The Great Grid Upgrade

Bramford to Twinstead Reinforcemen

Document 8.3.9: Applicant's Response to Issue Specific Hearing 1
Action Points

Planning Inspectorate Reference: EN020002

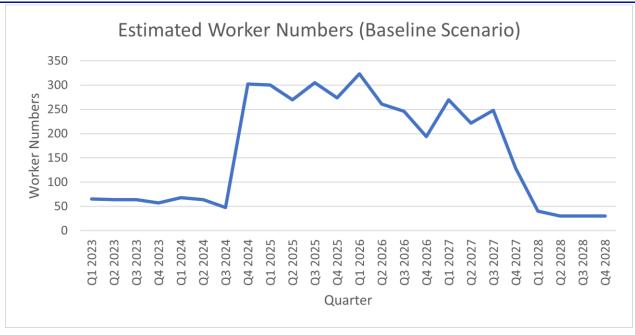
AP10	construction schedule scenario was used in making assumptions about the worker number profile. Provide the same information assuming the baseline schedule scenario was followed. Provide explanation about	The below graph details the estimated worker number profile during construction for the baseline schedule, as a comparison to the estimated worker number profile for the alternative scenario presented in Illustration 4.1 in ES Chapter 4: Project Description [APP-072].	N/A
	Provide explanation about the assumptions used for work and shift patterns and in determining peaks in the

Illustration 4.1 in Project Description [APP-072] indicates four peaks in estimated worker numbers occurring in Q3 2025, Q3 2026, Q2 2027 and Q3 2028. By reference to Illustration 3.1 (Alternative Scenario) in the Construction Schedule [APP-091] it is noted that these peaks correspond with the following activities:

- Q3 2025 The increase in worker numbers is for additional staff for cabling works associated with trenchless crossing;
- Q3 2026 commencement of underground cable installation and Stour Valley East CSE compound and continuation of work activities from previous quarter;
- Q2 2027 remobilisation of overhead line gangs associated with outages;
- Q3 2028 landscape planting as site demobilisation and general reinstatement works continue.
